Application for DCO by FOSSE GREEN
Representation by Interested Party reference [REDACTED]
Deadline 5A

Summary of Submissions

Fig1

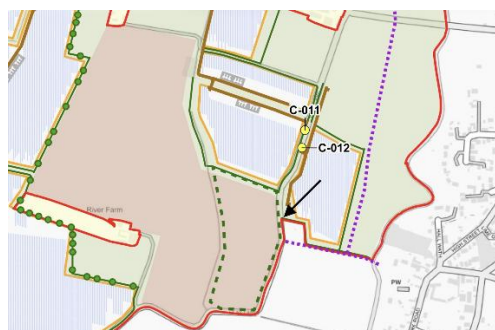
5.1.3 The Applicant suggests that new permissive paths will enhance local connectivity (paragraph 3.8.11 of the Health and Wellbeing Statement). How does the proposed permissive path along Clay Lane, Bassingham improve connectivity? It is a circular route from and to the existing public highway around the edge of an open featureless flat arable field. Fig 1 below is a photograph of the field taken from Clay Lane and the position that the photograph was taken is shown in Fig 2.
